# **Facelift of Mui Wo**

## **Summary of Public Views**

### **A. Public Views at Forum**

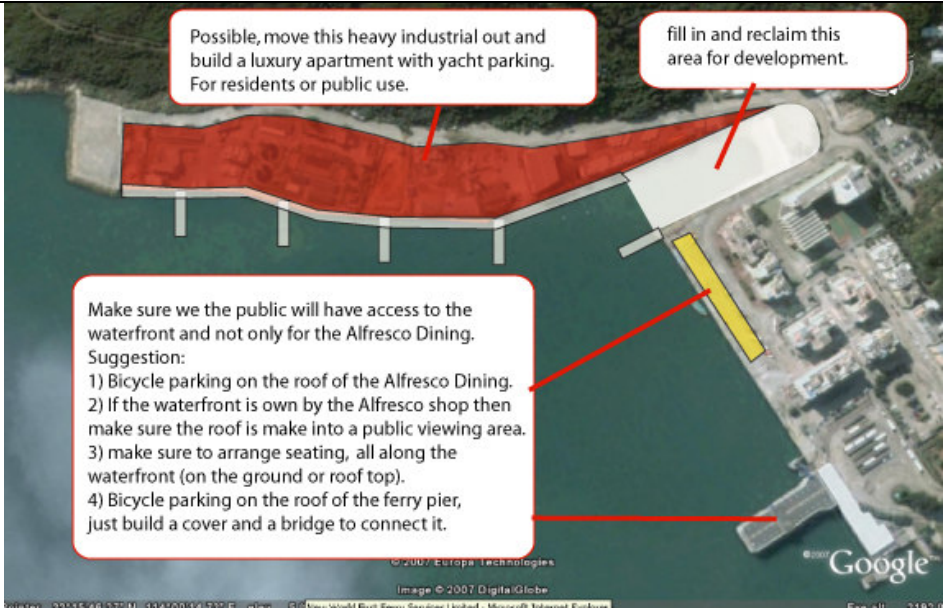
No.	Comments
	<p>2. <u>Bike lanes</u> – the lanes are useful on the road going to the pier, but not inside the villages. We don't see any danger riding on the paths inside the villages IF the relevant authorities can effectively stop illegal driving. Very often, we almost bump into incoming vehicles round the bend. This is the <b>ONLY</b> danger inside the villages. You can easily save a lot of money on this and channel the funds to improve other local facilities.</p> <p>3. <u>Toilet and Refuse Collection near the Food Court</u> – I welcome the relocation of these two structures away from the food court for obvious reason. But we see the need to make a further step to separate the toilet and refuse collection. It's a matter of concept. Going to the toilet is not just getting a hole to dump some waste. It's part of our existence and we deserve a respectful venue for this human activity. Please take a look at the public toilet at the entrance to Nan Chung, Fanling. Make Mui Wo a place of pleasant memory for visitors.</p> <p>4. <u>Green</u> – we certainly welcome more green. But living in a place with a lot of green, we have our specific need about green. We want to live in it, which means that we want to be close to it and touch it, but not something that is sealed off for decoration. Right now, there is no grassland that we can live on. If you really want to enhance the beauty and life quality in Mui Wo, I strongly suggest that you build some grass patches along or close to the coast/shore where people can sit down, lie down, relax, chat and enjoy the sea and the mountain range. And make the park pets-friendly. Look, by doing so, Mui Wo will be a unique place in HK.</p> <p>5. <u>Eco-town</u> – since we have the rare opportunity living close to nature, we should endeavour to protect it and live with it in harmony. Some suggestions:</p> <ul style="list-style-type: none"> <li>a. Explore eco-friendly facilities e.g. solar-driven street lights / pier lights instead of just replacing them for consistency.</li> <li>b. Promote organic farming</li> <li>c. Develop compost flower beds/parks – build community composters and use the compost to fertilize the flower beds and suggested parks. It solves part of the waste problem and there again, make Mui Wo a unique place that hopefully inspires other communities to do the same.</li> </ul> <p><b>D. About sculptures</b></p> <p>Sculptures in public space are hype. The misuse of public space is one concern. The aesthetic value is another. In our context, I strongly request you to follow up the 'sculptures' in Mui Wo's public space.</p>

No.	Comments
	<p>1. <u>The bauhinia statue</u> – Nobody, including government officials and district councilors, dared to tell the residents in the forum who and how the proposal was approved. While the residents see this as important information, we were denied of it, making it doubtful as to whether the consultation means anything to the final design. We were told that the proposal had been approved outside the remit of the facelift plan. But since the plan is something that turns Mui Wo into a ‘yet-to-be-decided’ new face, how can something as prominent and CONTROVERSIAL as the bauhinia statute be left out of the design? As one of residents in the forum commented, for a grand objective of ‘revitalising the local economy’, it calls for the coordination of all relevant government developments. If the Planning Department cannot even coordinate with the local district council and office, how much hope can the Mui Wo residents have towards working on a plan that appeals to the majority of those who live here?</p> <p>2. <u>Oversized animals</u> – The controversial and offending ‘sculptures’ of oversized animals pose the same problems listed above.</p> <p>I believe that it is the responsibility of the Planning Department and the consultancy company to trace the decision making process in this two controversial use of the public space. It is also your responsibility to inform us, either through you or the relevant bodies, WHEN and HOW it was decided, and HOW MUCH it cost.</p> <p>3. <u>Planned sculpture</u> – In the pier area layout plan, a sculpture will possibly be put in the roundabout. I request that instead of sourcing it from who knows where, you mobilize the creativity of the local community and facilitate the artists and other members of the community to create the sculpture. This can be replaced at certain intervals. Financially, it cuts down the cost. Culturally, local people are involved in the cultural development of their community. And economically, it will be yet another local asset unique in its approach of creation, adding to its attractiveness to visitors and potential islanders.</p> <p><b>E. Period of consultation and feasibility study</b></p> <p>The consultancy company is given a tight schedule of 10 months to do the feasibility study as against 15 months for Tai O. I wonder why you think it can take shorter to do the study for Mui Wo. The issues are no less controversial, and the local dynamics among villages are no less complicated in Mui Wo. Particularly in view of the queries and suggestions made by me and other residents, there is more than legitimate reason to extend the FS period so that more and GENUINE discussions with a wide spectrum of Mui Wo residents can be undertaken. Similar requests have been raised in the public forum on September 8, and I await your response.</p>

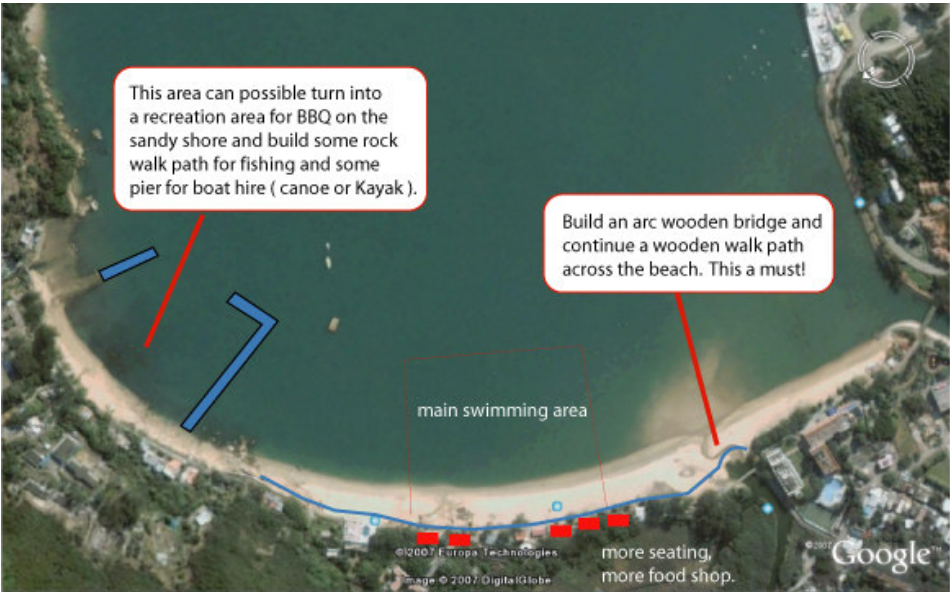
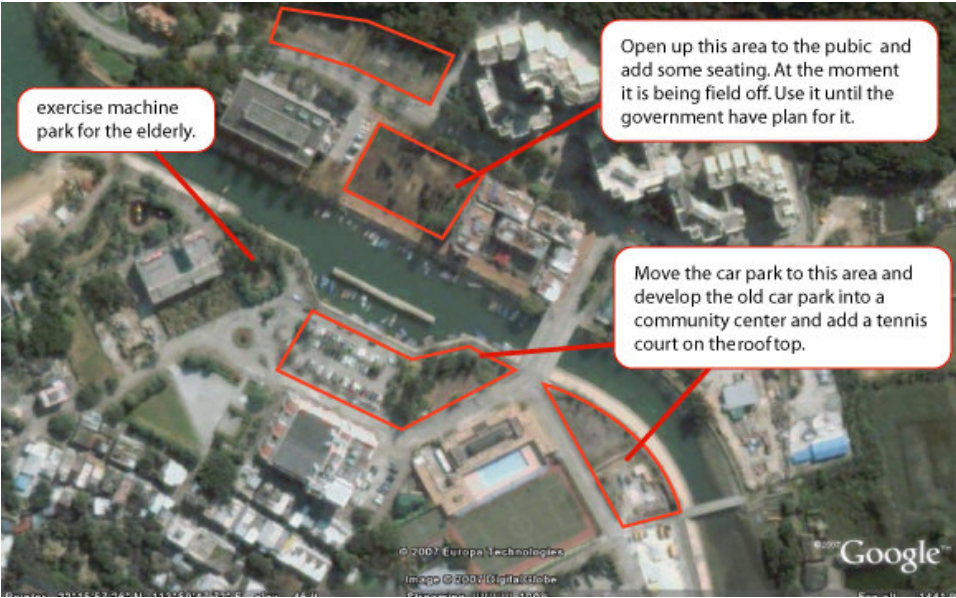
5.19	<p>I attended the Mui Wo Public forum on Sept 8<sup>th</sup> 2007.</p> <p>It was my first time to able to attend any Mui Wo forum and would like to voice my opinion on the forum and your “facelift” proposal.</p> <p>Firstly, what is the purpose of this improvement work on Mui Wo is for?</p> <ol style="list-style-type: none"> <li>1) Is it for the local resident benefit?</li> <li>2) Is it for attracting more tourists’ benefit?</li> </ol>
